SEWAGE DISPOSAL SYSTEM

HOWARD COUNTY HEALTH DEPARTMENT
BUREAU OF ENVIRONMENTAL HEALTH

PROPERTY OWNER Dr. Victor A. Fazekas
1475 Route 32

REPAIR - PURPOSE - Septic System Has Failed.

48461

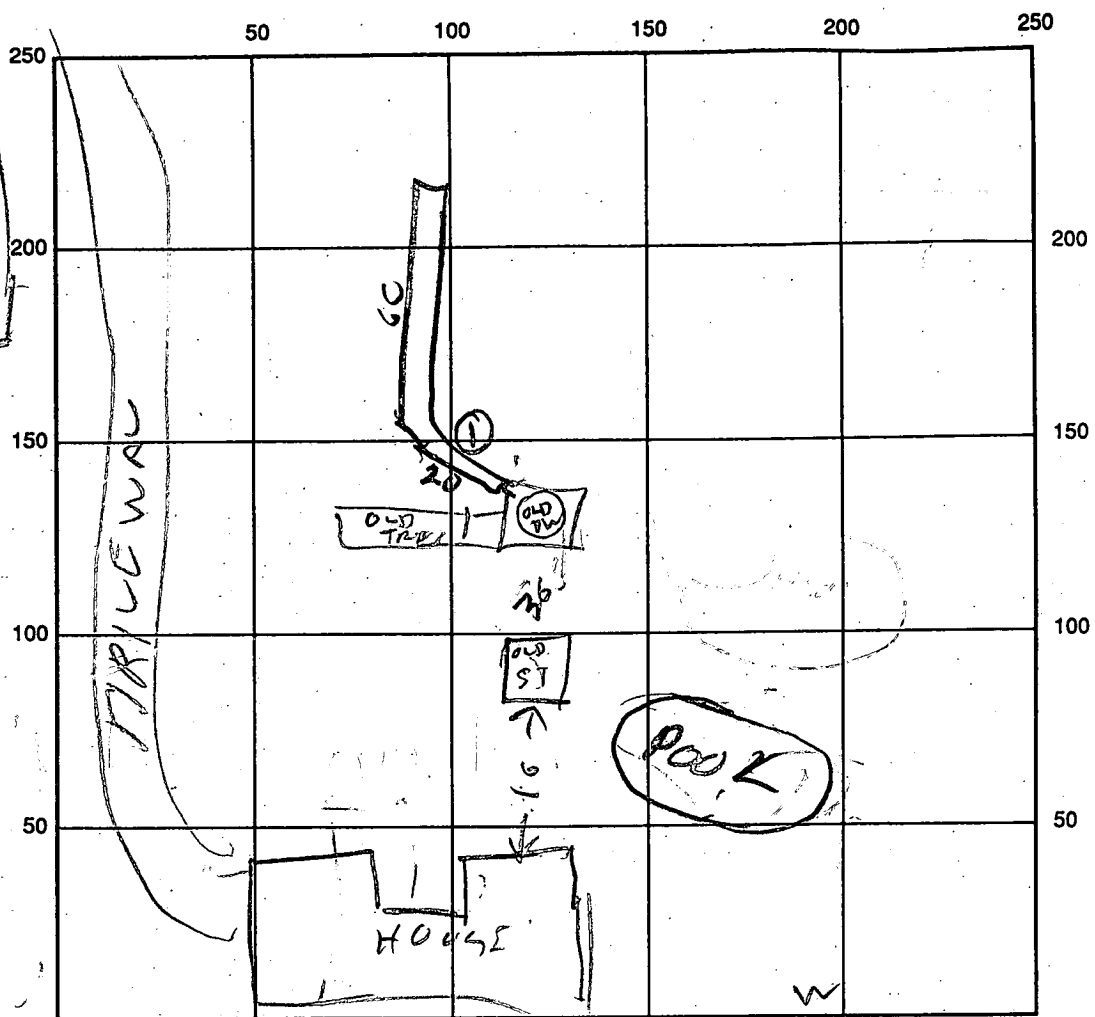
Call for inspection when ground is opened so sanitarian can recommend repair. 8/24/92

TRENCH - 2 FT WIDE 72 FT LONG 11 FT DEEP
INLET 4 FT 17 FT OF STONE PLACE
TRENCH OFF OLD DRY WELL
8/24/92 R.H.

REMARKS: 8/24/92 - SOIL VERY GOOD. OLD SYSTEM INSTALLED 1979
8/24/92 - TRENCH FINISHED. HOME OWNER MRS FAZGROV
TOOK PICTURES. O

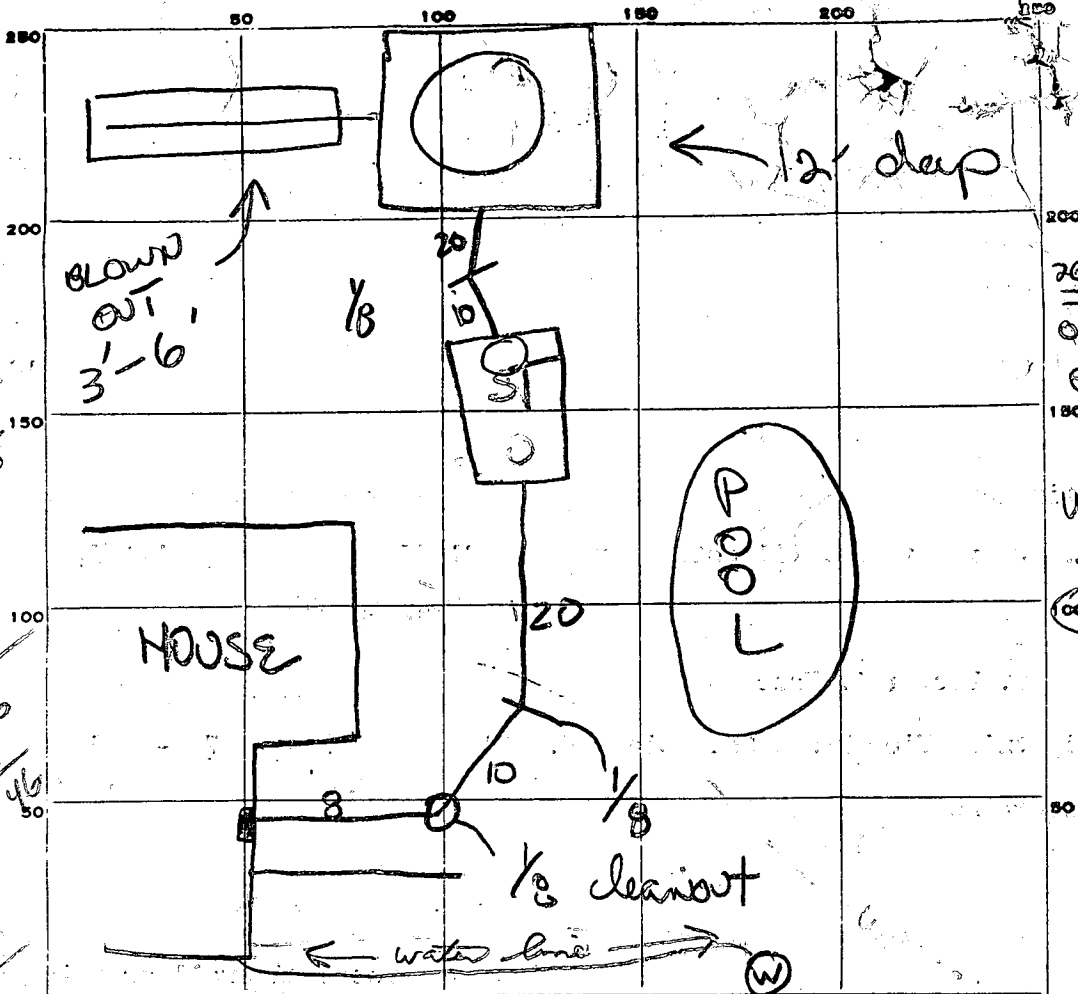
REMARKS 17 MAY 77 - See attached sheet. (GLK) 25 MAY 77 - letter sent to builder (GLK)
22 June 77 - Well water line under house sewer as indicated above. Short on area - Add 15' trench & call before adding gravel. Also manhole will be needed on ST. (GLK)
25 June 77 - Drywell inlet at 5'. Need to add trench 20' long - 13' deep. Call before adding gravel (GLK) 26 June 77 - OK for stone (GLK)

Place the dry well 420 ft. from the lot line which is 1372.08 ft. long and runs

N85degrees38 30 E and 200 ft. from the stone shown on the site plan. This stone

is the one which is the 100 ft. assumed elevation. Cleanout provided if sharp

bend in line between house and septic tank.

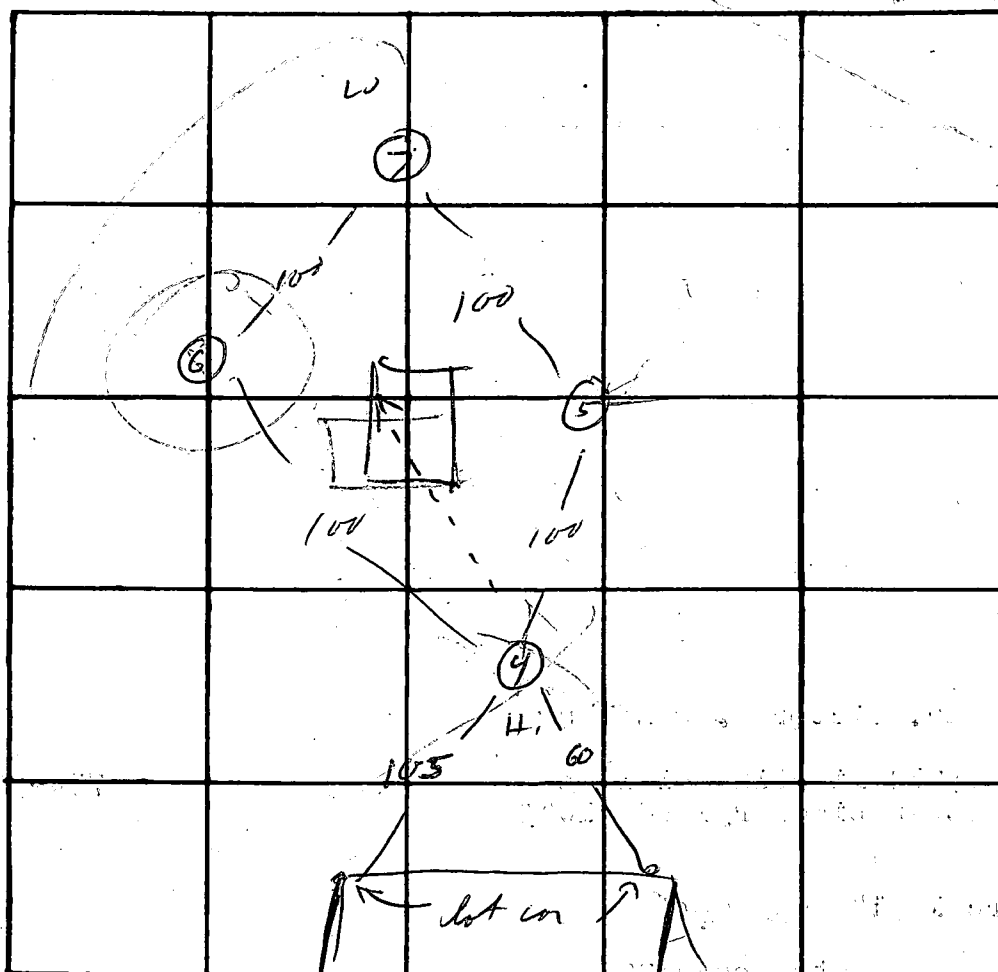
REASONS FOR REJECTION OR HOLDING Hold for wet season, test for shallow system

Δ in elev. hi. to 20' ~ 3'; for better location

The sewage disposal field will consist of trenches 2' wide and 9' deep with 6' of stone. The vertical usable sidewall area will be considered as between 5' and 9' below O.G. There will be 135th feet of absorbent sidewall area per bedroom in the trenches.

[BR - 1 trench 105' long; 4BR - 2 trenches 70' long] The trench(s) will follow the contour of the land. The first trench will begin at a point 105' from the corner of the 127' prop. line & the 134' prop. line, and 60' from the 134' prop. line & the 199' prop. line corner. If 2 trenches are used, they will be spaced 15' apart center-to-center. The trenches should be connected in series.

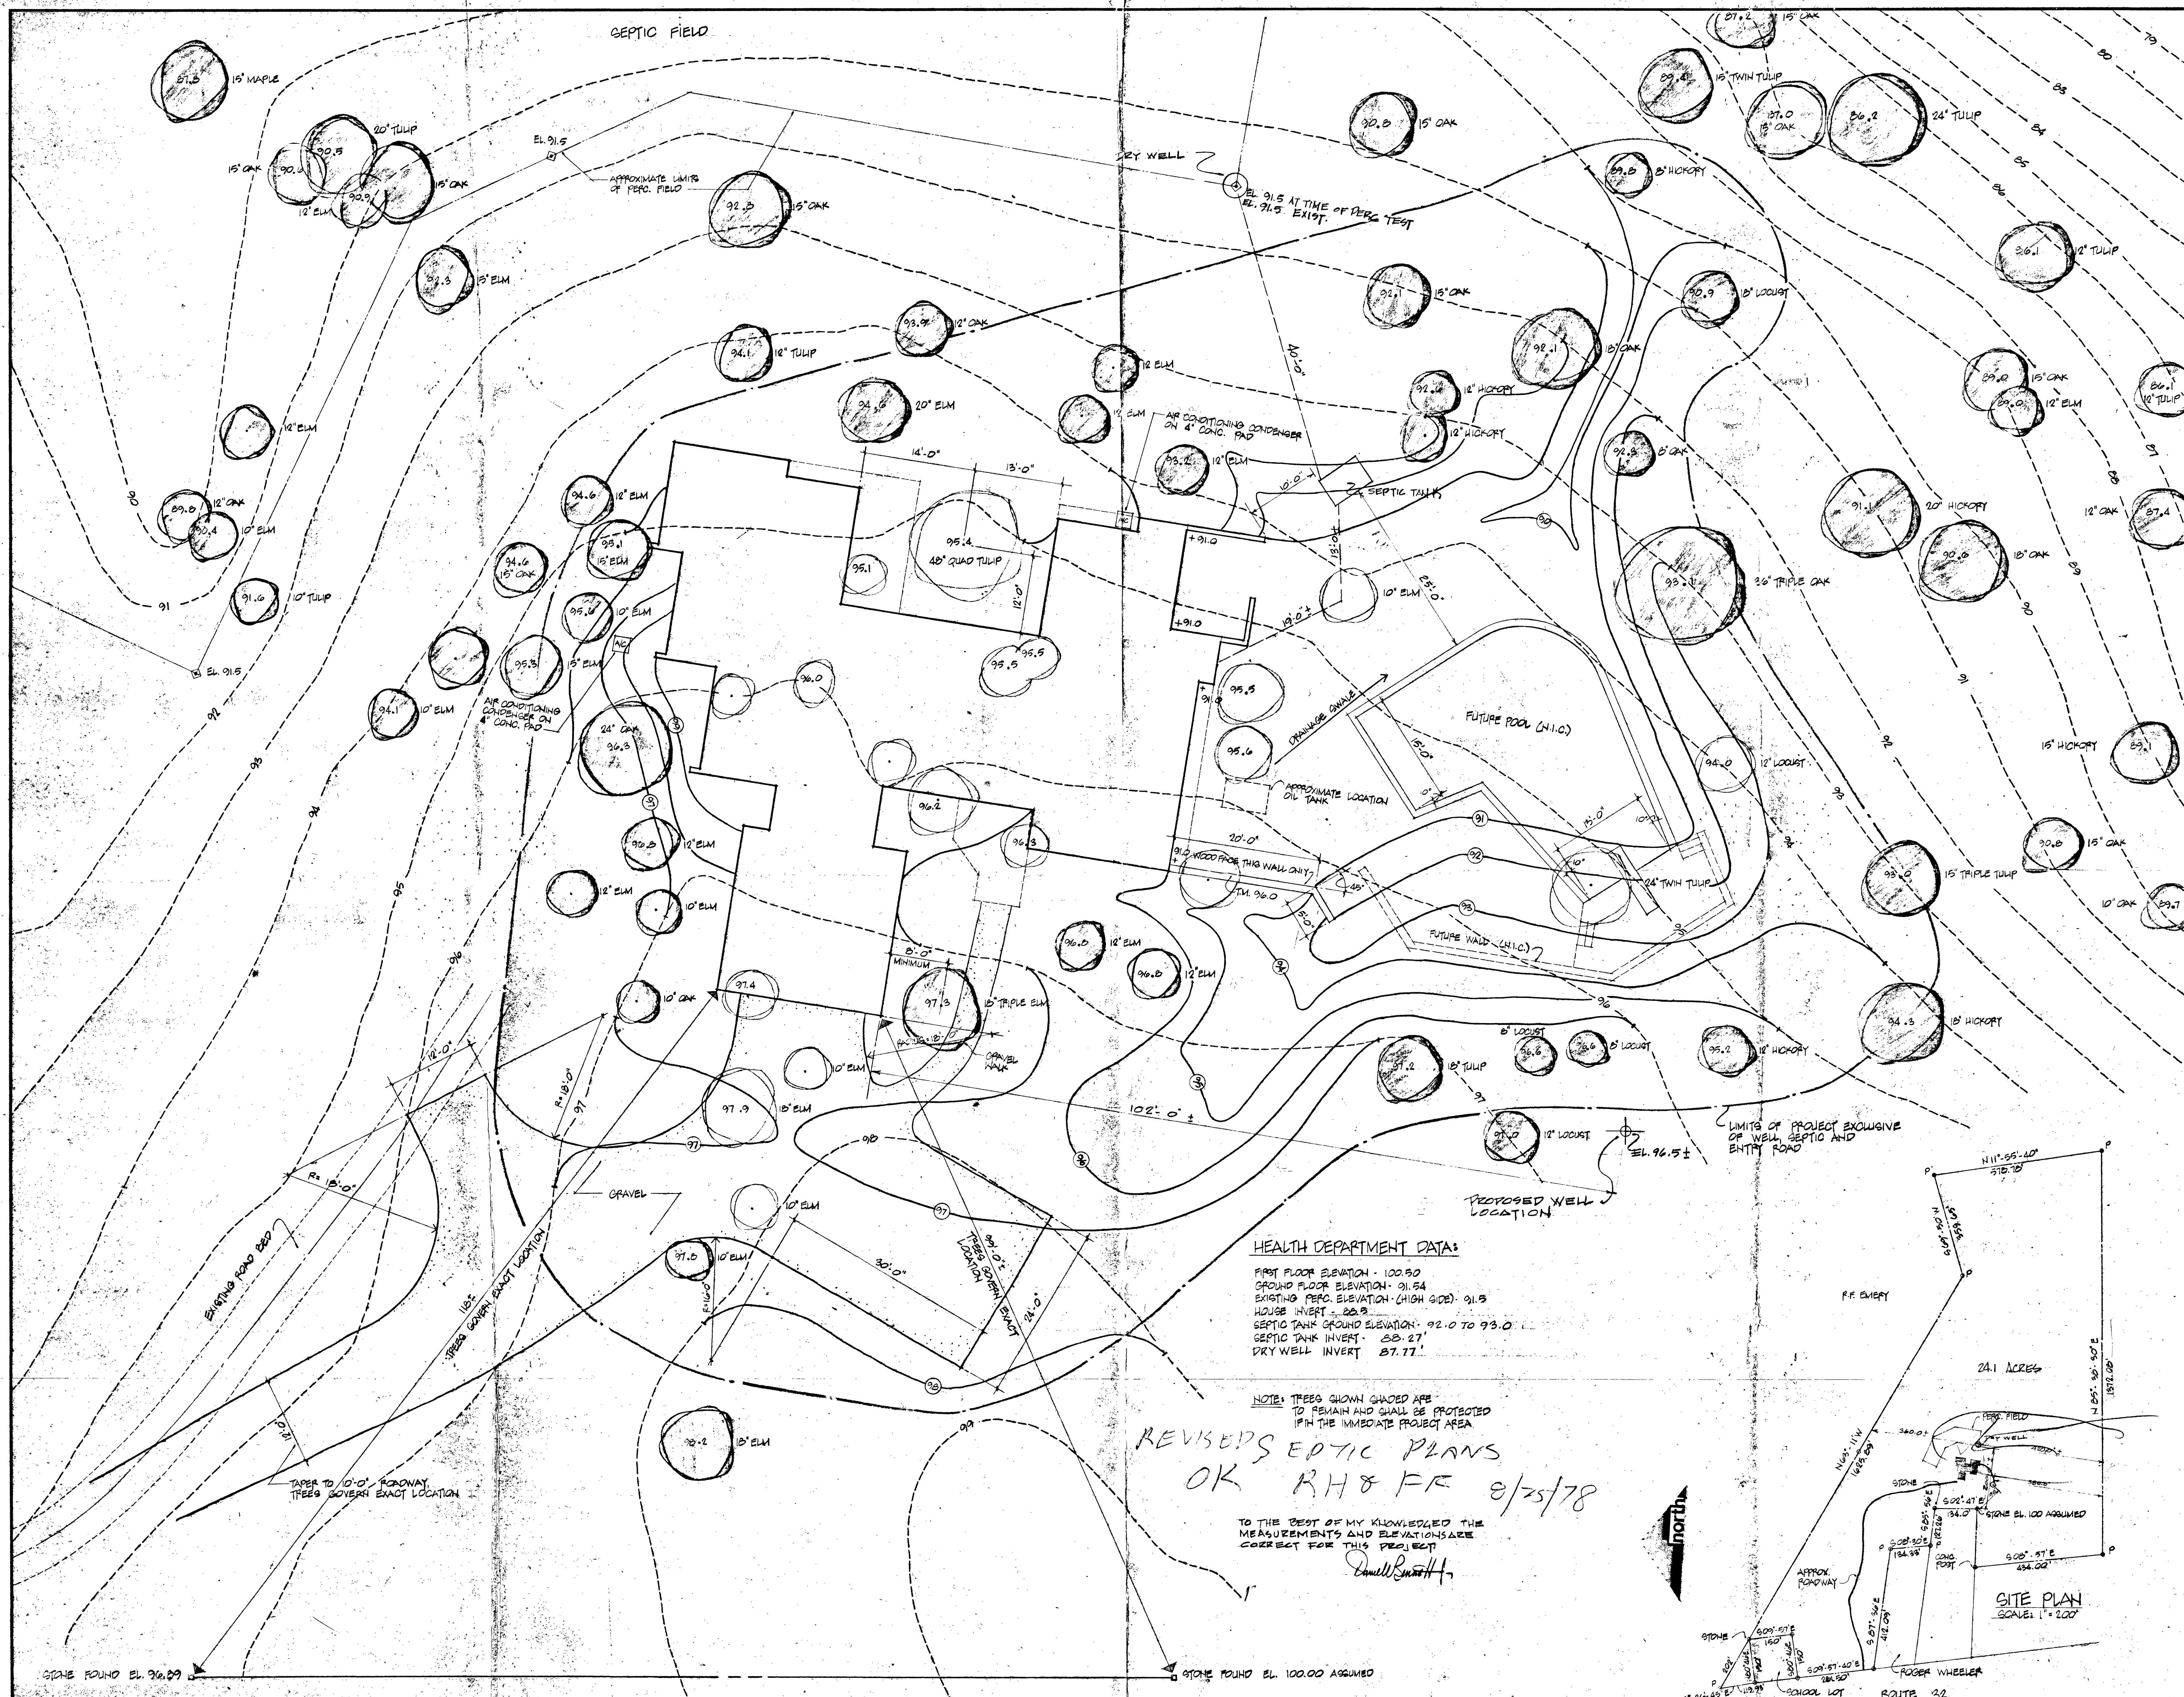
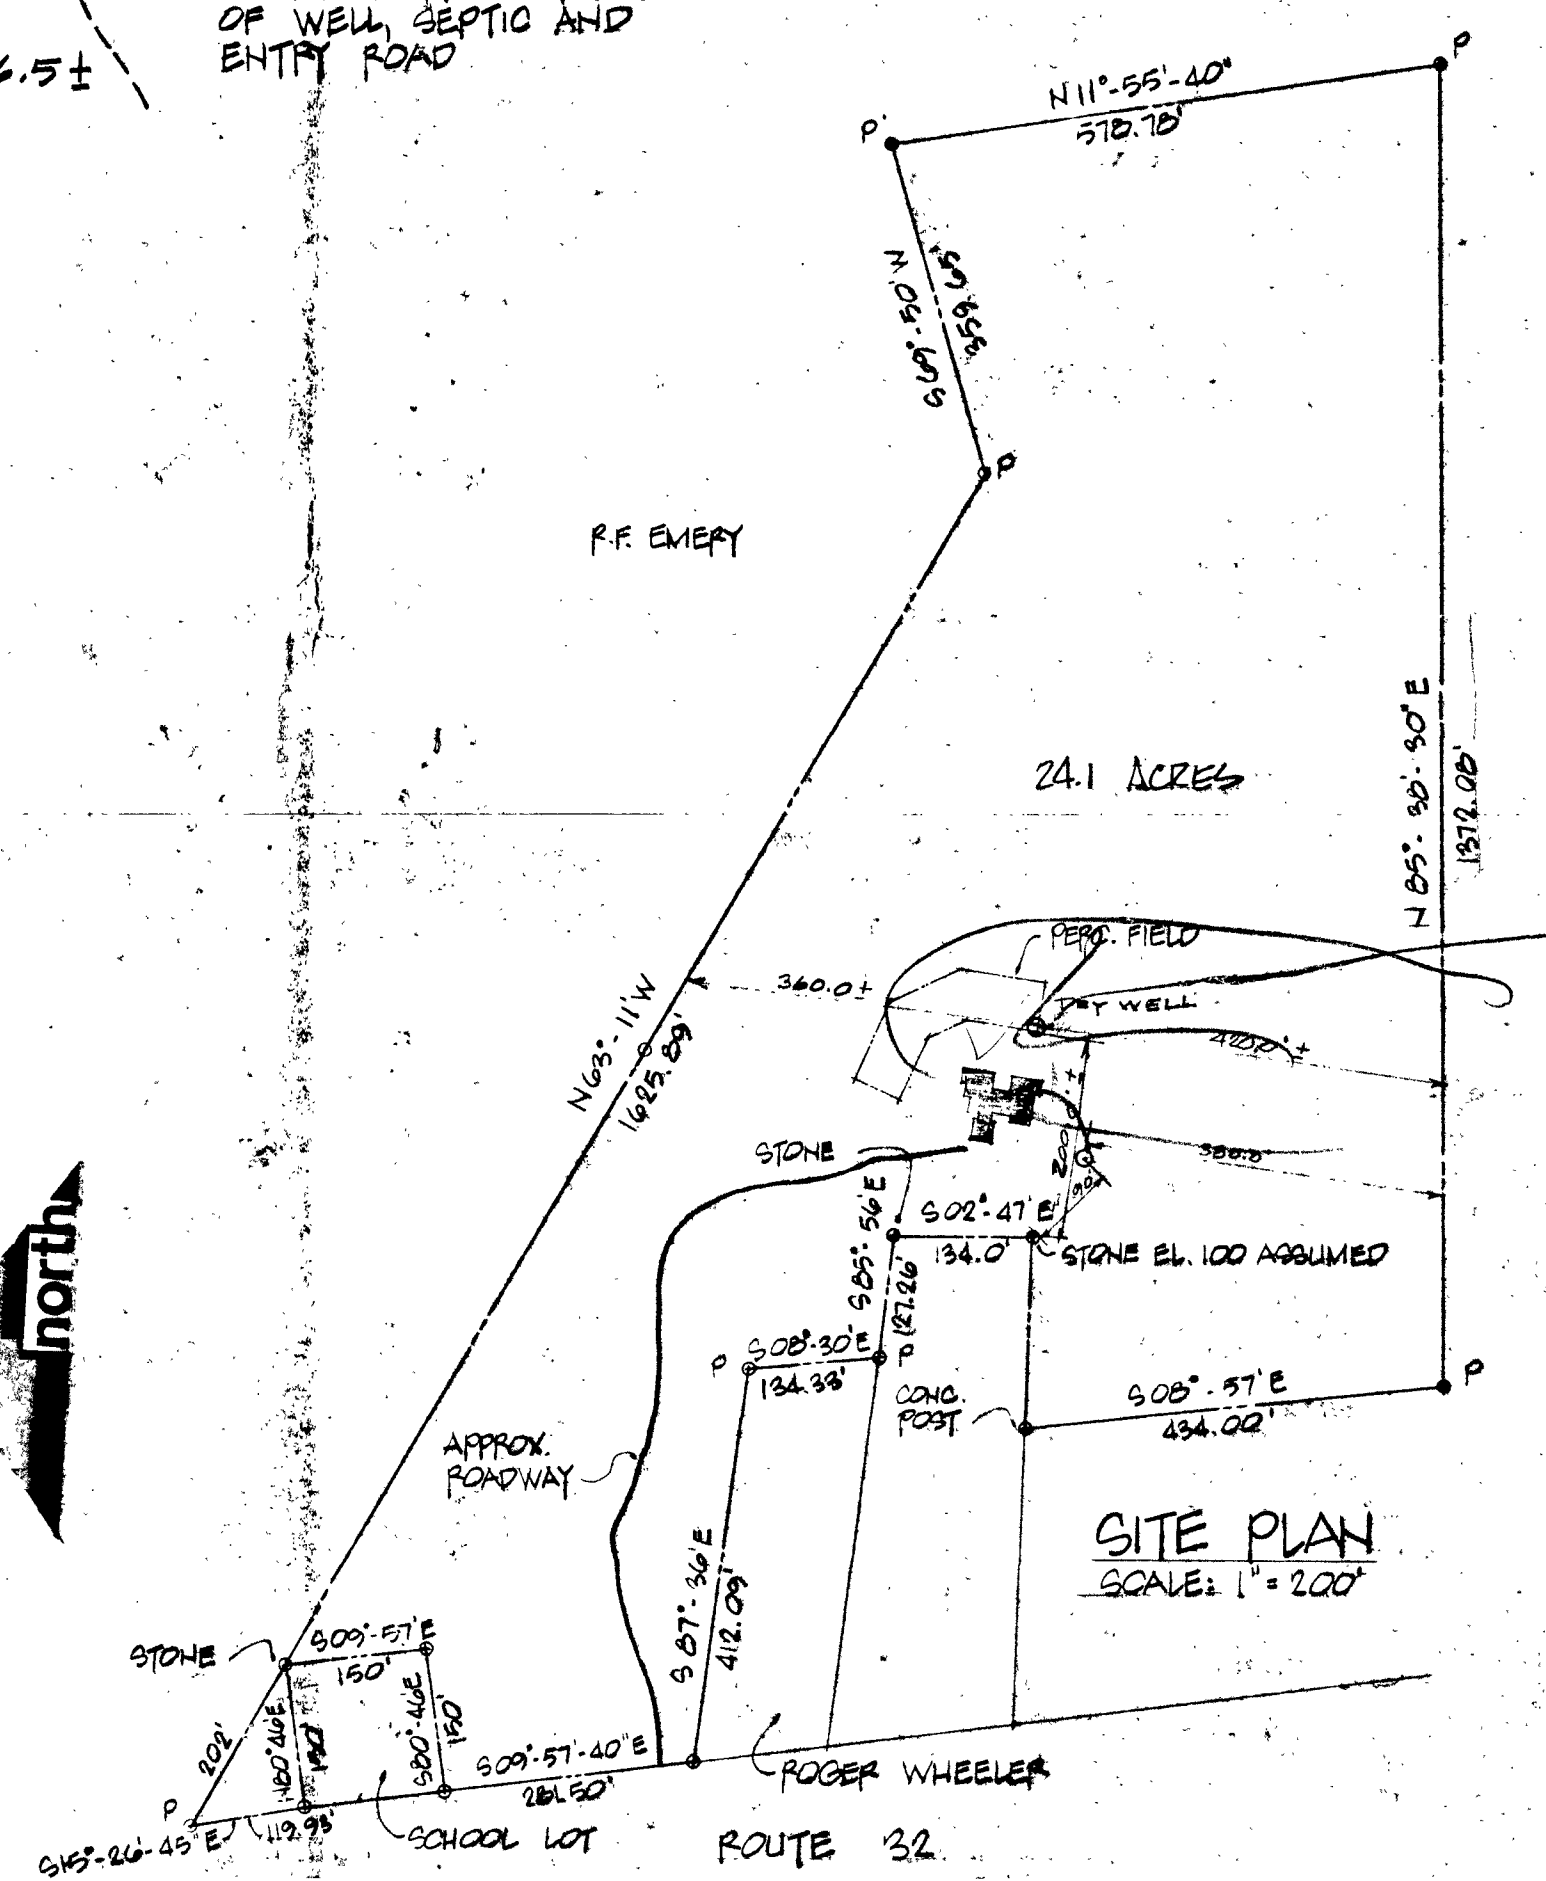
REVISED SEPTIC PLANS
OK RH & FR 8/25/78
